RE: 5 properties on Packard Ln NE

**Packard Lane Bulkhead Project
City Permit Nos. 2116 to 2120
Bainbridge Island, Washington**

RE: PACKARD LANE BULKHEAD PROJECT, CITY PERMIT NOS. 2116-2120

DRAWING NUMBER
 Fig 1

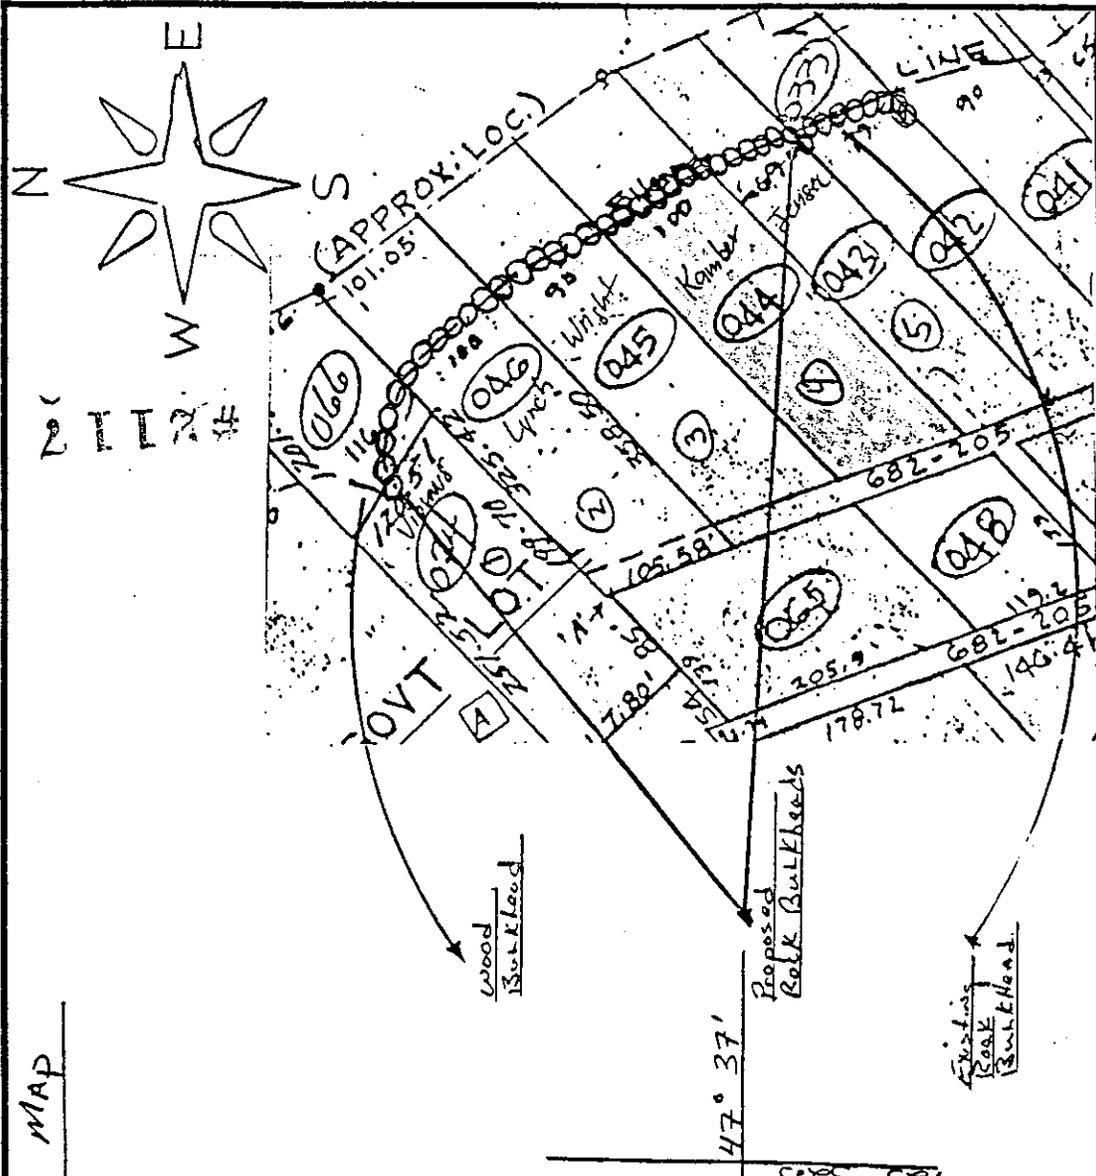
The bulkhead alignment shown in Figure 1 is not located precisely, but the general plan appears to be satisfactory, because it ties to an existing bulkhead at its easterly end, ties into natural ground in a shallow cove at its westerly end, and follows a smooth, curved alignment between the ties. Consistent with legal provisions of the construction permit, the bulkhead should be constructed close to the bluff, with the alignment controlled at points where the bluff projects farthest into the harbor. At these control points the back of the bulkhead should be about five feet from the bluff at the base of the quarried rock portion.

DRAWN BY JOE
REVISED
DRAWING NUMBER
FIG 2

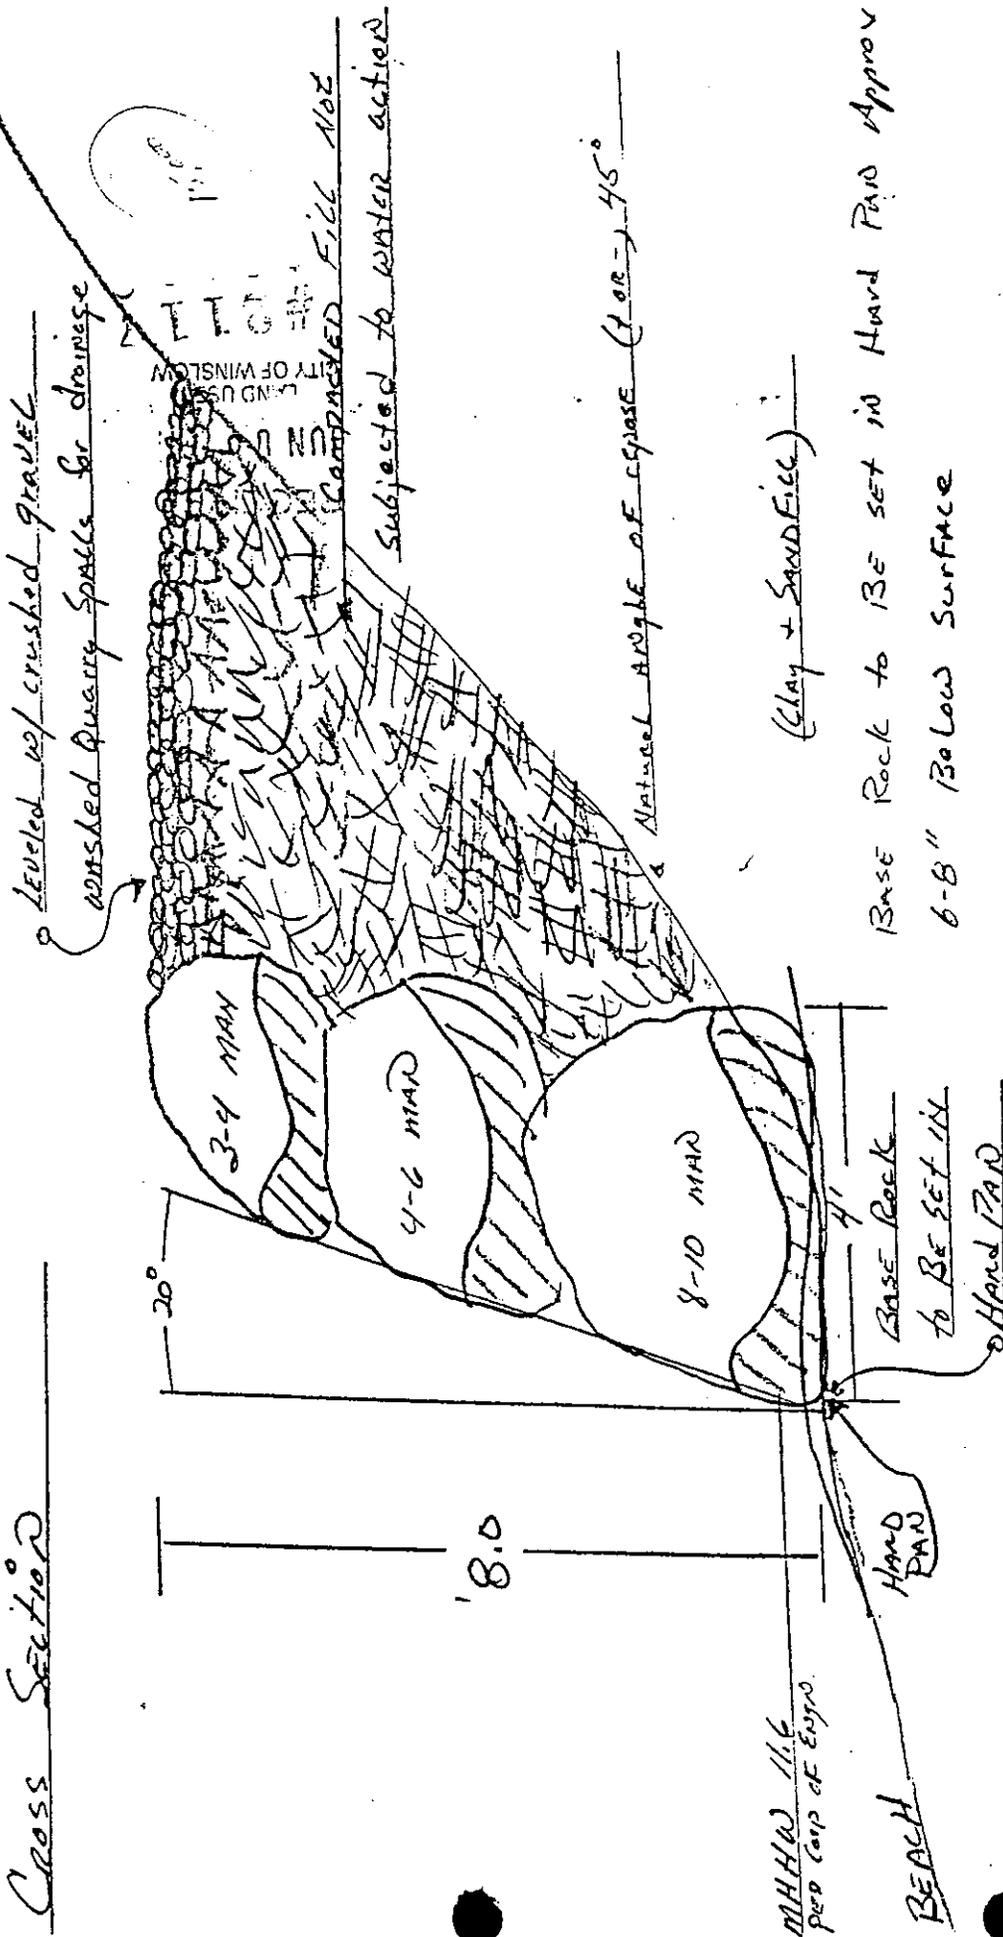
The proposed bulkhead cross section shown on Figure 2 should be revised. At this location, except for a thin sand cover the beach materials are hard clay. After the bulkhead is constructed, material on the beach will continue to erode, so the bulkhead will be undermined unless the base of the rock is set well down into the clay. The depth of embedment should be about two feet. The embedment needs to be only beneath the quarried rock face.

The ground at the base of the bluff is rounded similarly to that shown on the section submitted with the application, but the bluff above the top of the bulkhead is nearly vertical. There is no definite measurement point for establishing the distance from the base of the bluff to the rock portion of the bulkhead; that is somewhat a matter of judgment. However, it is the intent to preserve a minimum distance of about five feet between the back of the quarried rock portion of the bulkhead and the base of the bluff where the rounded toe of the bluff joins the relatively flat beach slope.

The proposed bulkhead slope and height is satisfactory.

Fill behind the quarried rock face as proposed is not suitable. The entire space between the quarried rock face and the bluff should be filled with quarry spalls. Crushed gravel or washed quarry spalls are not needed at the surface, but would not be detrimental. The compacted fill with unspecified gradation, as proposed in the application, could contain fine material that would erode through voids in the rock and cause the bulkhead to fail.

Quarried rock for the bulkhead face should be of high quality and suitable to resist weathering. It should be free of cracks and joints that could open by freezing and thawing or wetting and drying, and it should be angular and relatively cubical in shape. Rounded and flat elongated pieces should not be used. Stone sizes at the base of the bulkhead should measure 3 to 4 feet in average dimension. The size can gradually taper so stone sizes measure 2 to 3 feet at the top of the bulkhead. Stones should be set individually in a tight, interlocked mass with minimum void spaces between the stones.
